HISTORIC AND DESIGN REVIEW COMMISSION July 15, 2020

HDRC CASE NO:	2020-307
ADDRESS:	515 BURLESON ST
LEGAL DESCRIPTION:	NCB 514 BLK 18 LOT 9
ZONING:	R-6, H
CITY COUNCIL DIST.:	2
DISTRICT:	Dignowity Hill Historic District
APPLICANT:	Stephanie Padua
OWNER:	Patricia Gonzalez
TYPE OF WORK:	Porch flooring replacement
APPLICATION RECEIVED:	June 25, 2020
60-DAY REVIEW:	Not applicable due to City Council Emergency Orders
CASE MANAGER:	Huy Pham

The applicant is requesting a Certificate of Appropriateness for approval to install 2x6 treated boards as porch decking.

515 Burleson St. Front Deck Rehab Project

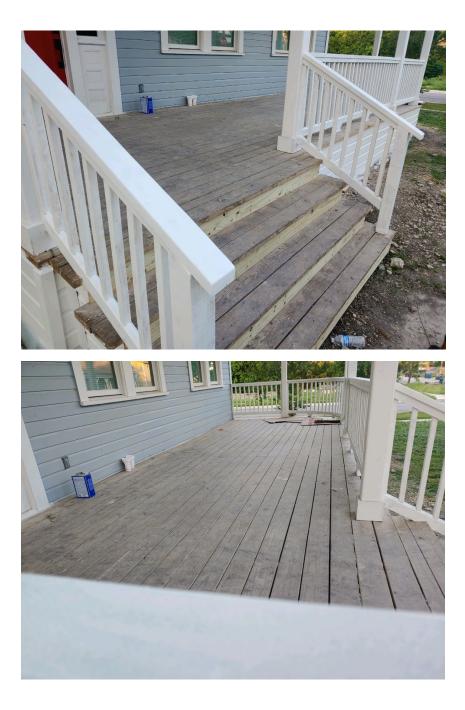
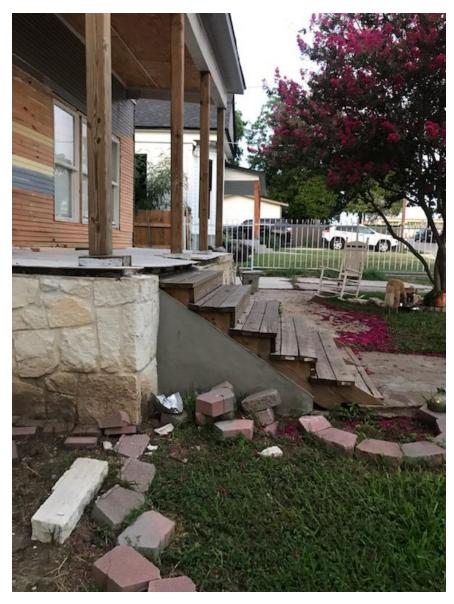
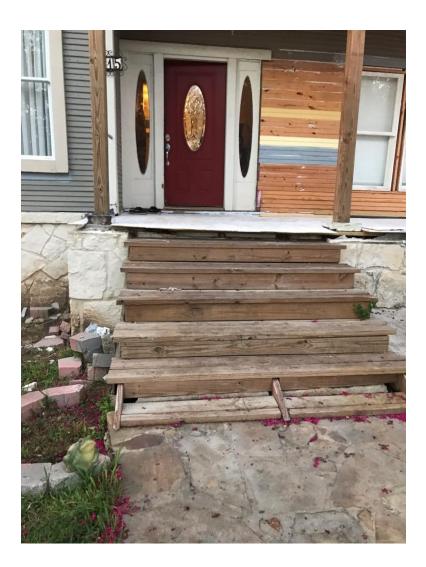
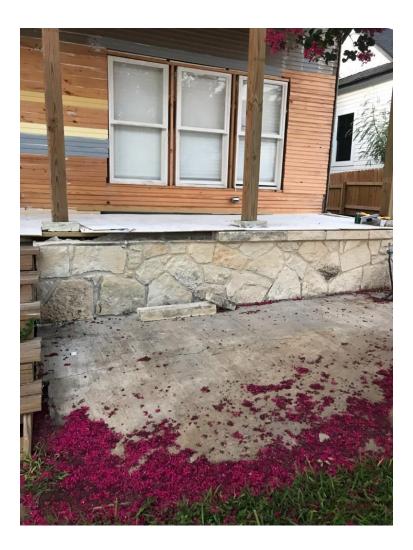
- c. PORCH DECK The applicant has proposed to replace the existing plywood decking with 2 x 6 wood planks laid parallel to the front façade plane. Per the Guidelines for Exterior Maintenance and Alterations 7.B.v., applicants should reconstruct porches, balconies, and porte-cocheres based on accurate evidence of the original, such as photographs; if no such evidence exists, the design should be based on the architectural style of the building and historic patterns. Staff finds that historic porches should be reconstructed with 1 x 3 tongue-and-groove wood decking laid perpendicular to the front façade plane and that the proposed 2 x 6 planks are inconsistent with the Guidelines.

- i. That 1×3 inch tongue-and-groove wood decking laid perpendicular to the front façade plane is used instead the proposed 2×6 inch wood planks laid parallel,
- ii. That no additional Certificate of Appropriateness may be issued until all corrections per the June 6, 2019, Commission Action have been completed.
